DAVID ROBERTS IEng FIHE FCiHT

DEALING WITH HIGHWAY AND TRANSPORT MATTERS

THE WELSH MINISTERS (THE CHESTER TO BANGOR TRUNK ROAD IMPROVEMENT (A55)
(JUNCTIONS 16 AND 16A IMPROVEMENT REALIGNMENT AND SLIP ROADS) COMPULSORY
PURCHASE ORDER 202-

AUGUST 2021

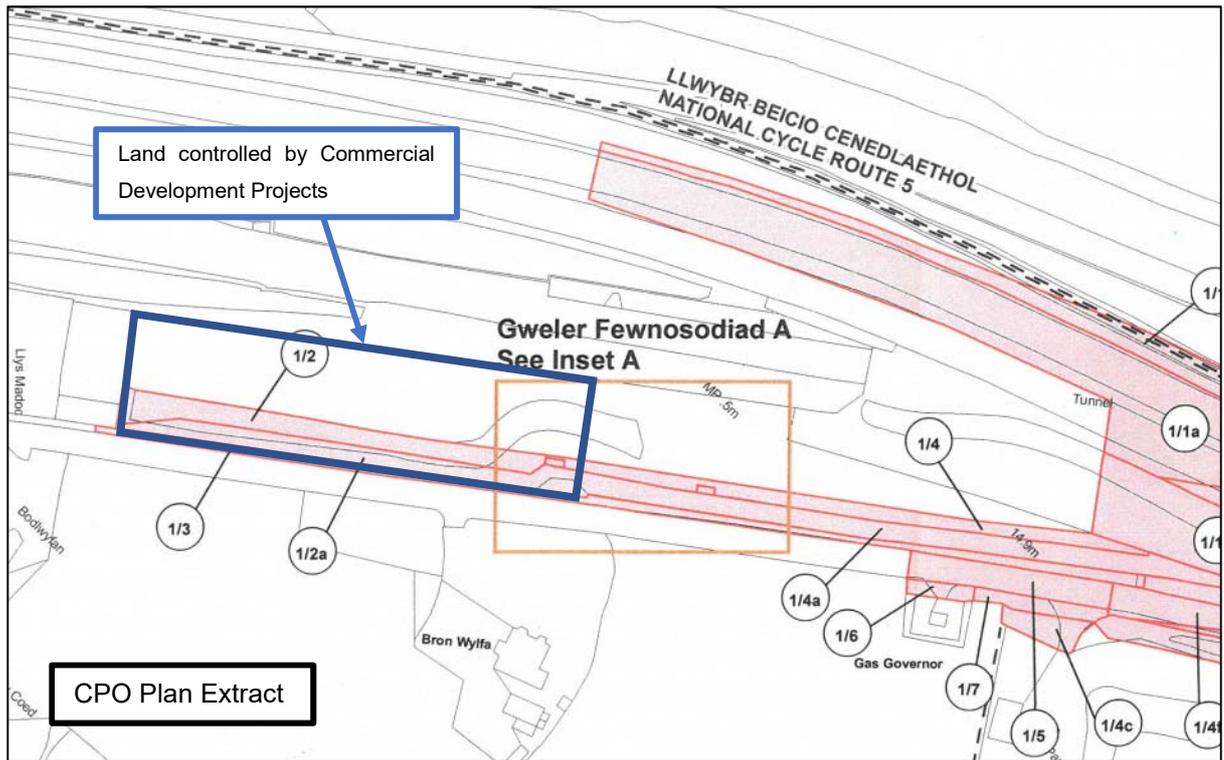
2.1 My statement deals with the highway and transport aspects of the proposal by Welsh Government to compulsory purchase land from my client in order to provide a shared footway and cycleway, along with a retaining wall and working space for the construction of these works. The CPO area sought by Welsh Government and the land controlled by my client is shown on the plan extract below:

2.2 My client has secured a planning permission on their land to provide 14 dwellings that would be, at best, seriously impacted by the proposals and detrimental to the approved development, and, at worst, would make the development unachievable. At this stage, and unless an amended planning permission is achieved, the latter scenario looks to be the more likely outcome of the CPO. The approved development layout plan and the accompanying decision notice are attached as **Appendix 1**.

2.3 The case put forward in my Statement relates to the principle that there is no essential need for my client's land to be the subject of the CPO and that without the CPO and the related works along the frontage of their site there would be no material detriment to the objectives of the works that have led to the need for the CPO.

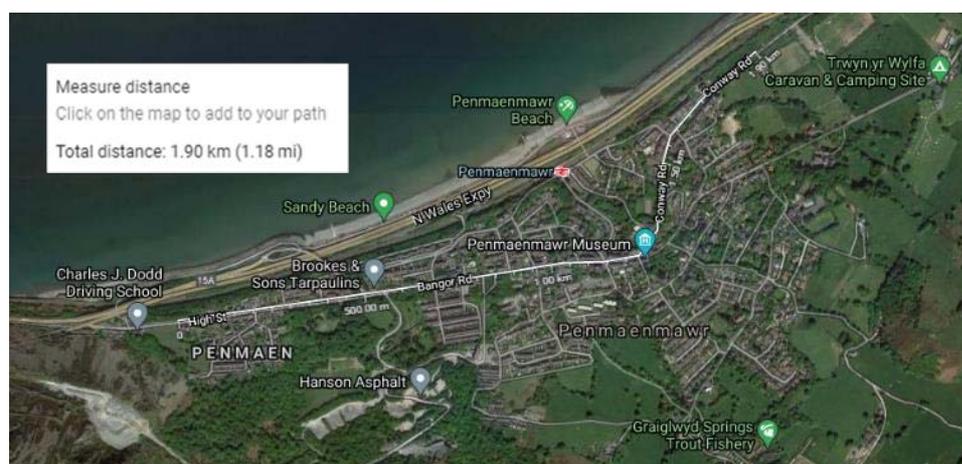
5.3 For clarification, the shared footway/cycleway is a 3.0m facility that is separated from the carriageway, effectively having the appearance of a wide footway, but shared with cyclists. It is proposed to start on the western edge of my client’s land and continue for some 270m on the north side of Conway Road to a point beyond the football ground access. It will then cross Conway Road to the south side and continue towards Dwygyfylchi, some 1.7km to the east. The plan below shows the indicative shared footway/cycleway proposal along Conway Road and the indicative extension of the urban area including my client’s approved development:

5.4 It should be noted that there are no cycle facilities to the west of my client's site and the cycleway is proposed to finish on my client's site frontage where cyclists would be expected to join the carriageway. There is a signed on-carriageway cycle route through part of Penmaenmawr which directs cyclists through a subway to National Cycle Route 5 which runs along the north side of the A55.
